REMARKS

Applicant acknowledges the Office Action dated June 13, 1995, in which the Examiner rejected all claims pending in the application and objected to the Drawing and specification for several reasons. Applicant has amended the application and respectfully traverses the objections and rejections for the reasons set forth below.

FIG. 1

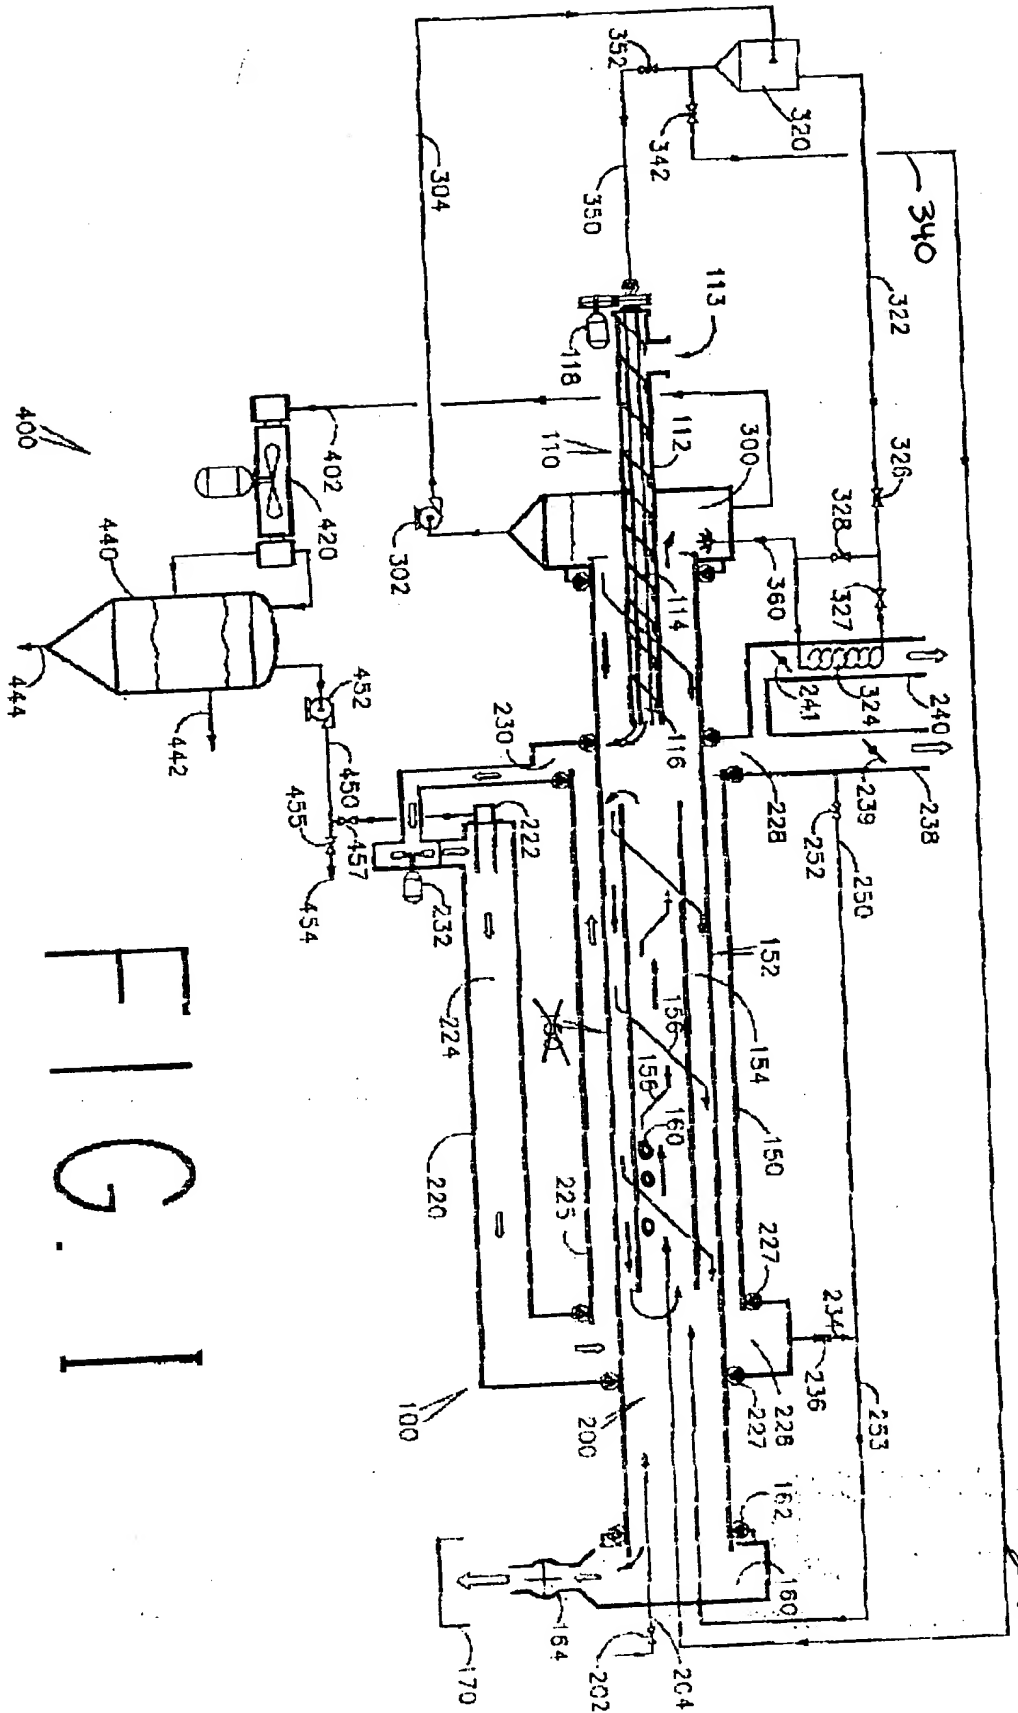
Applicant has submitted herewith a Proposed Drawing Amendment, in accordance with the Examiner's suggestion, and submits that the grounds for objecting to the drawings have been eliminated. The reference numeral "253," which refers to the stream of exhaust gases, has not been added to the Figure, as it appears in the original Figure, near the right-hand side.
